ADDENDUM NO. 1

RE: Sewer Interceptor Replacement – Camden Water Utilities, Camden, Arkansas

ADDENDUM DATE: July 13, 2022

Job No.: CM-01-22
Scale: 1"=50'
Date: JUNE 2022
Sheet 3

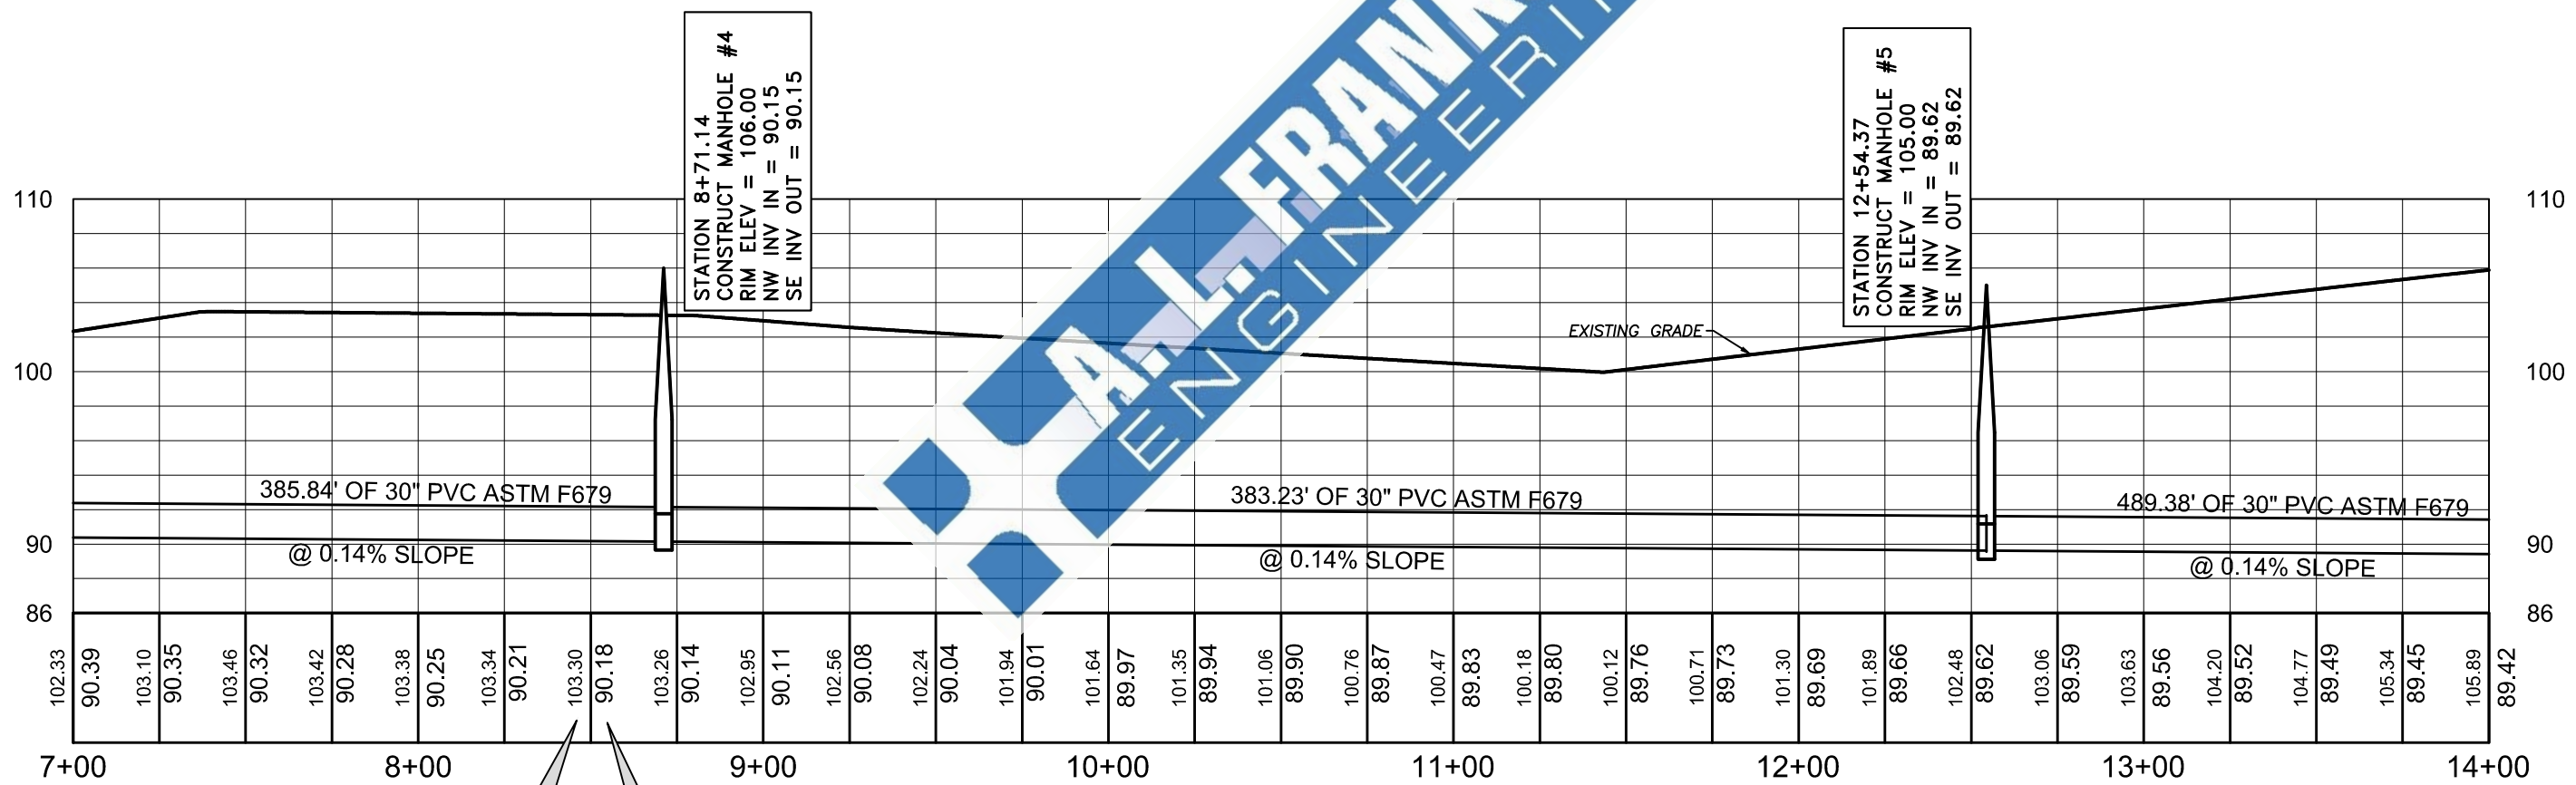
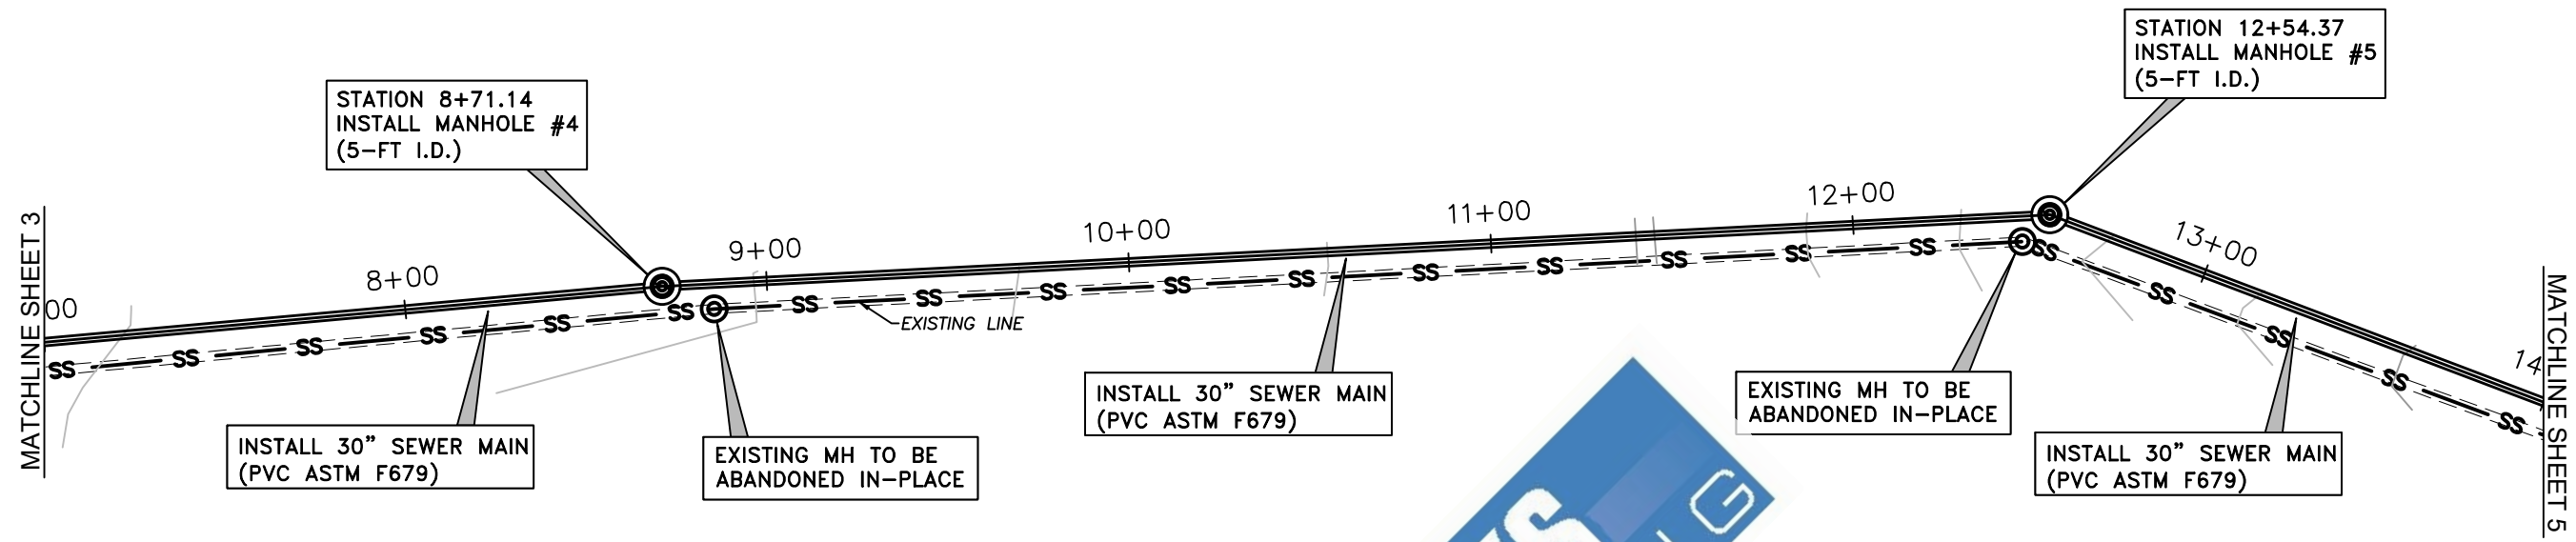
#1	7/11/22	CONNECT MH #2 INV.	JCH
No.	Date	Revision	By

Job No.: CM-01-22
Scale: 1"=50'
Date: MAY 2022
Sheet 7

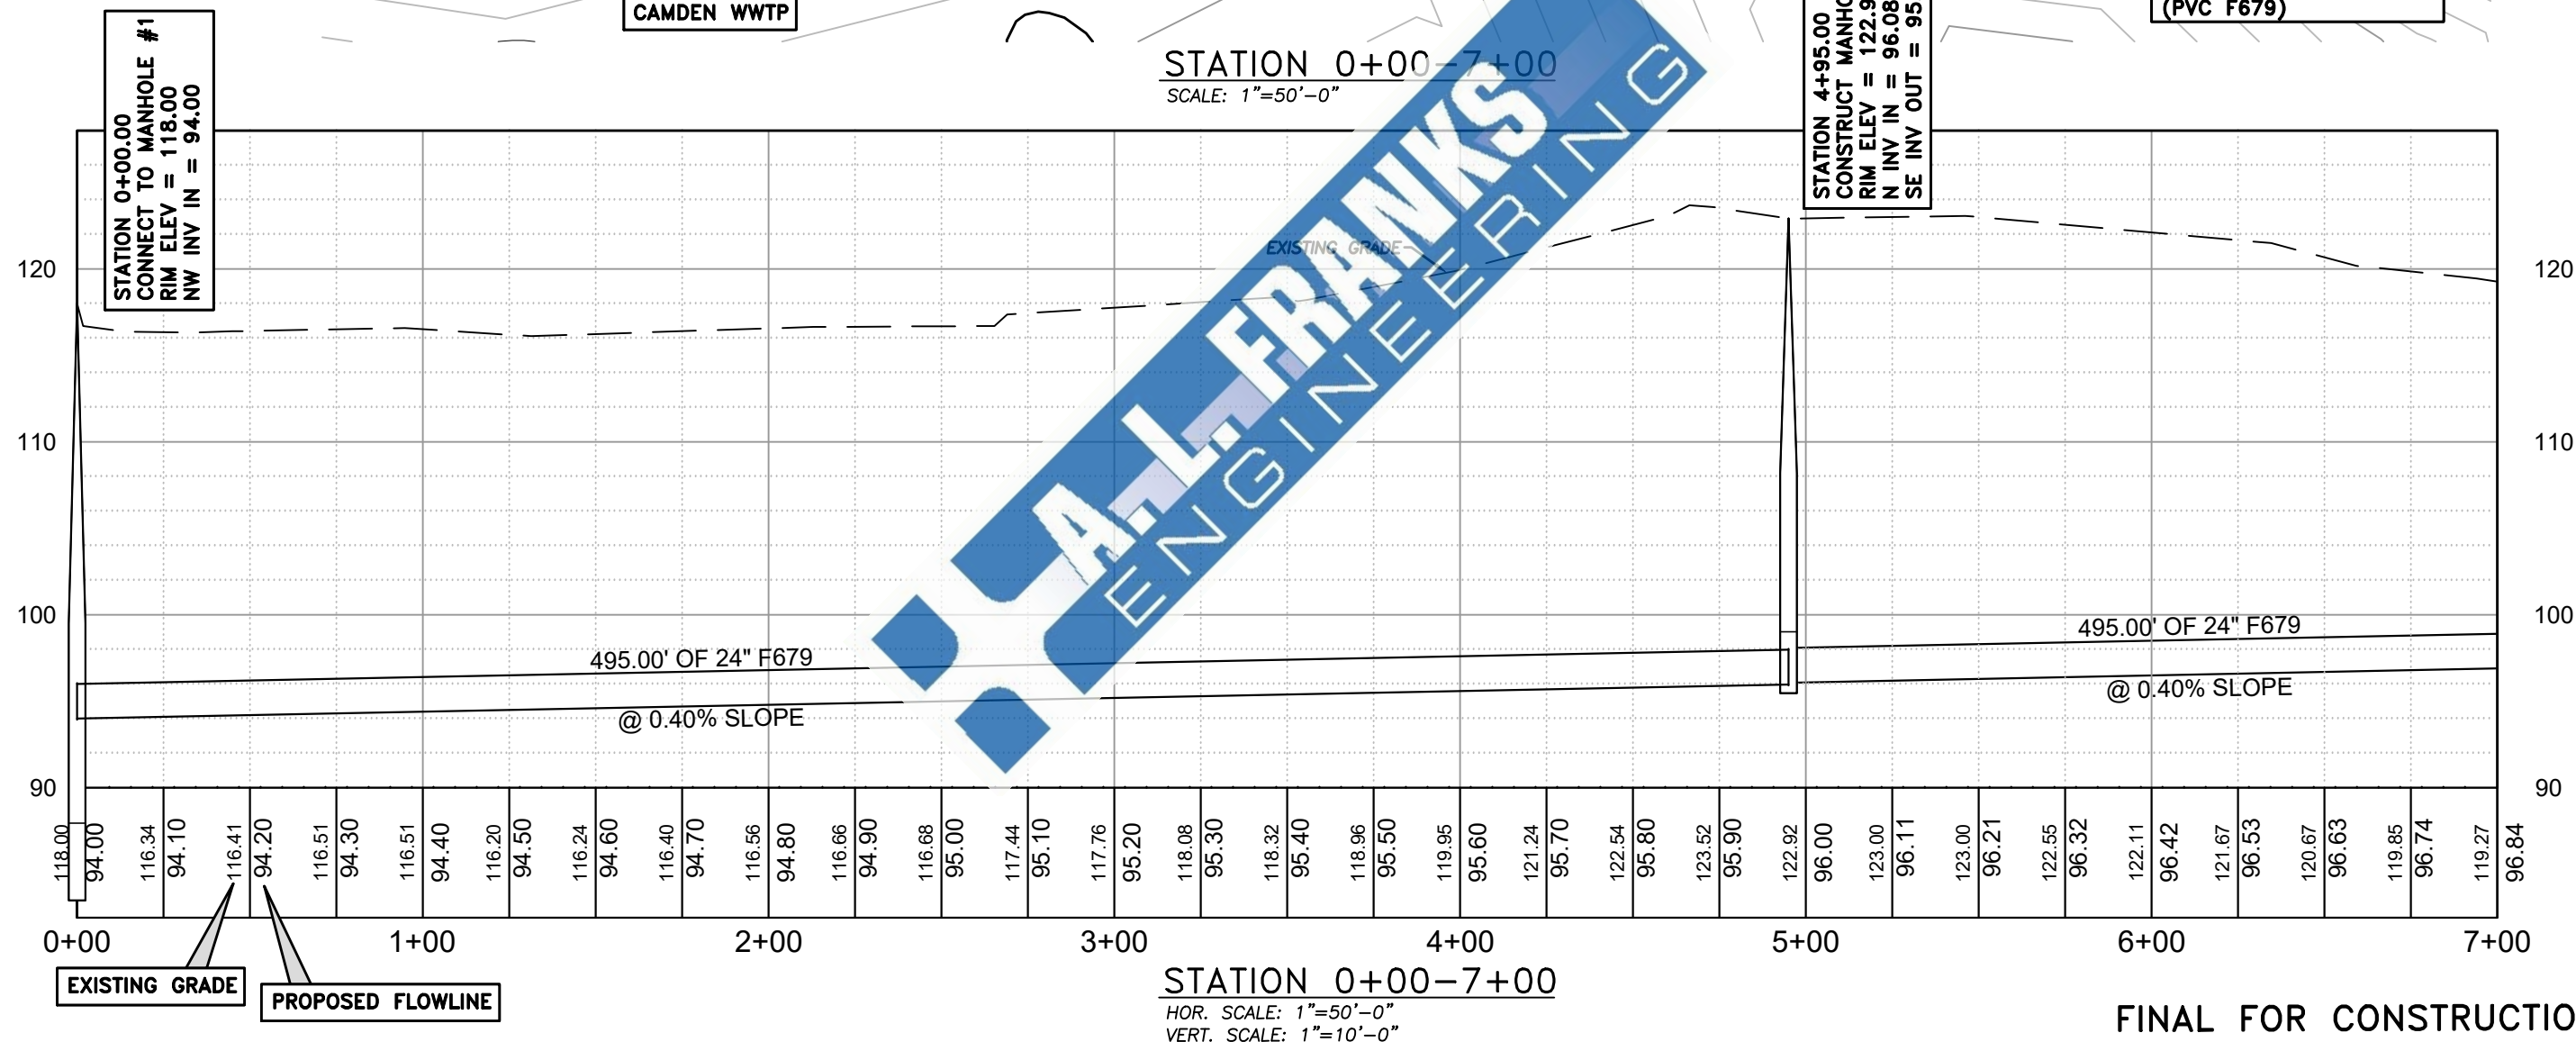
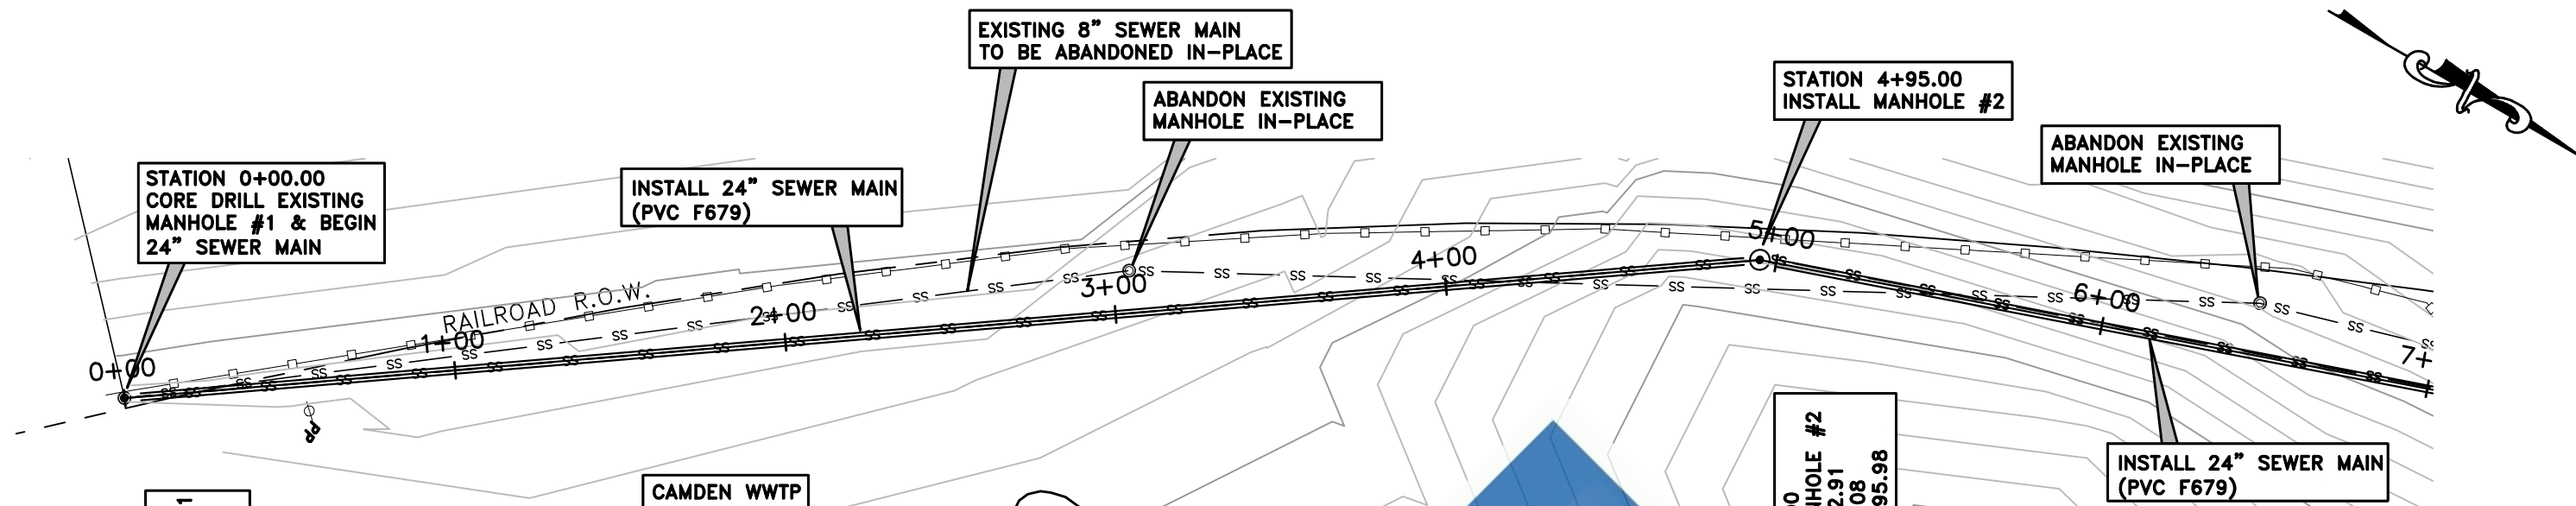
#1	7/11/22	CONNECT MH 9	JCH
No.	Date	Revision	By

Job No.: CM-02-19
Scale: 1"=50'
Date: AUG. 2021
Sheet 8

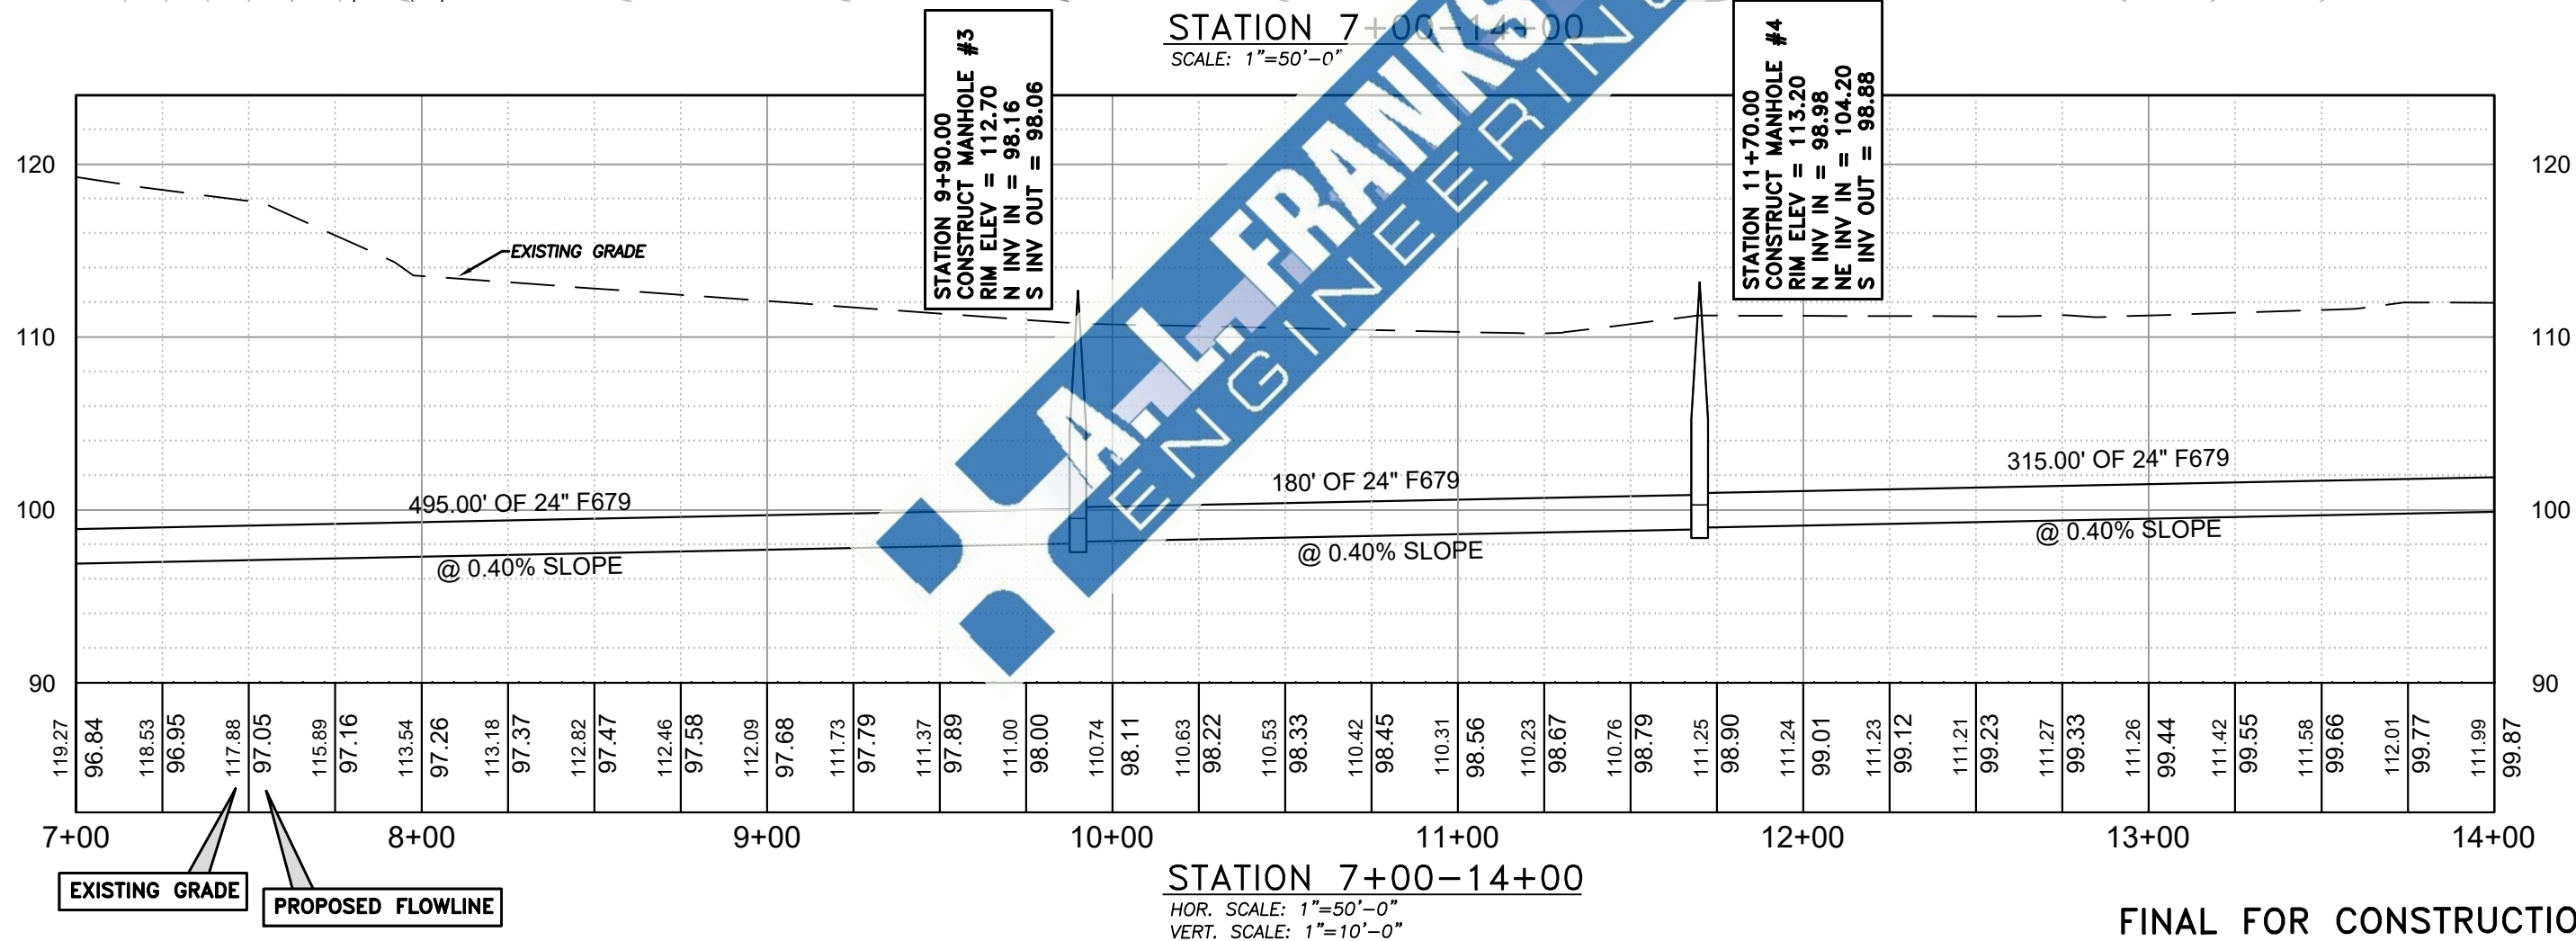
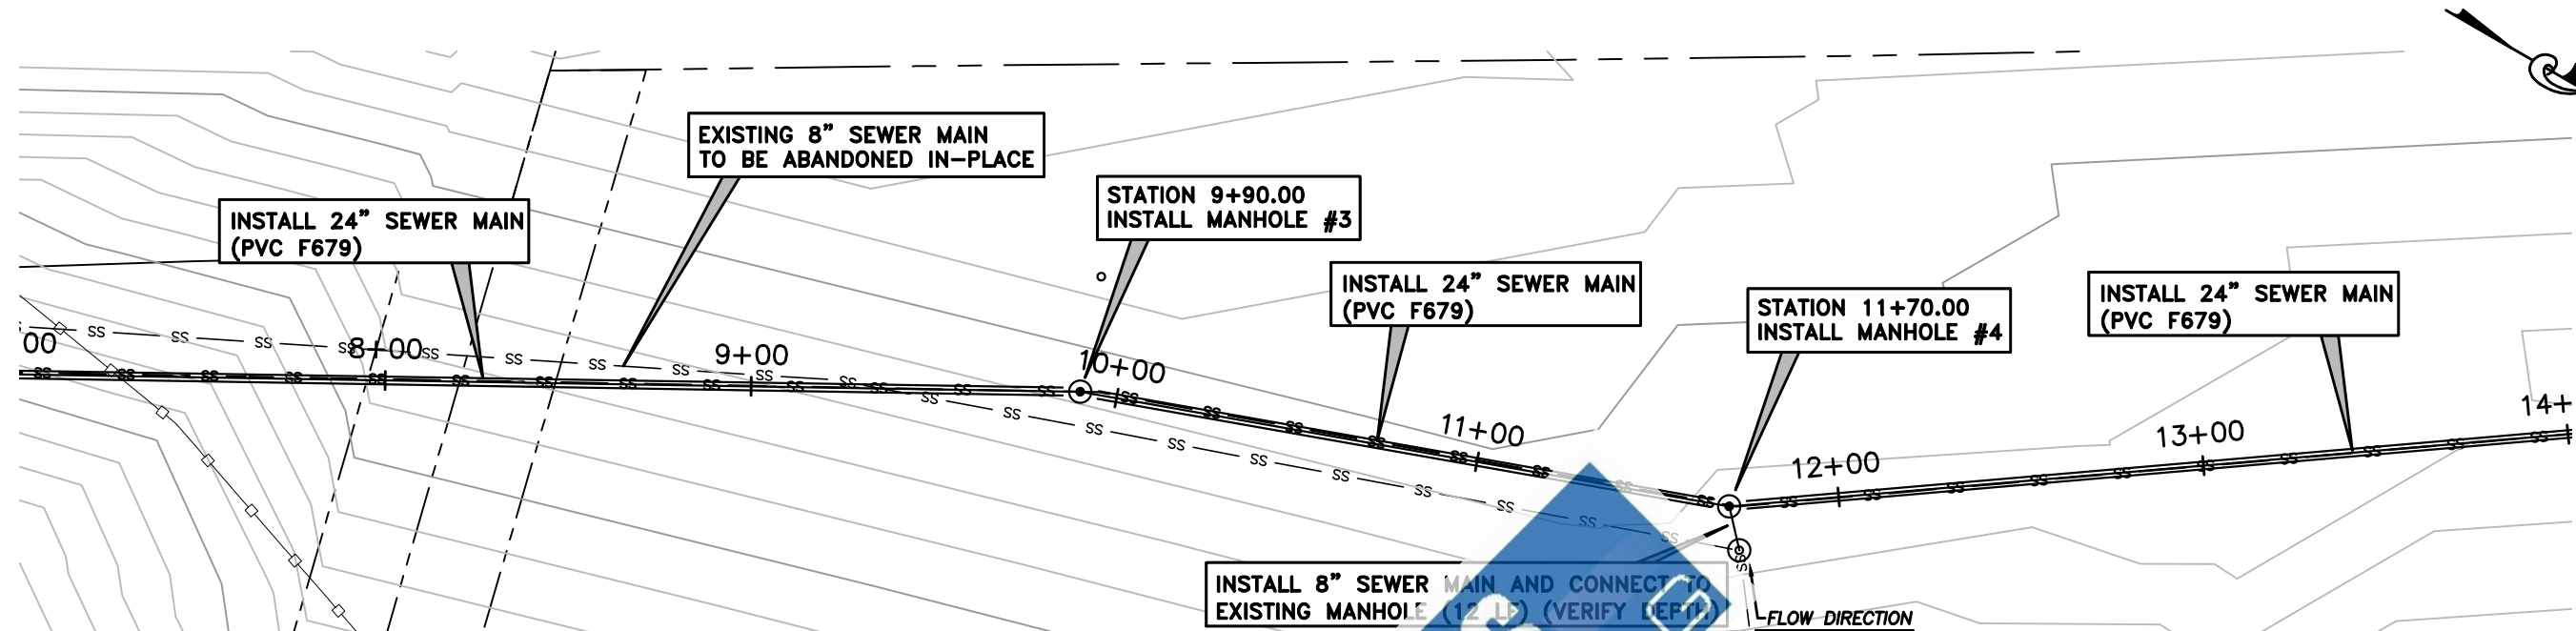
#1	7/11/22	CONNECT MH #1 / PIPE SLOPE ADJ.	JCH
No.	Date	Revision	By
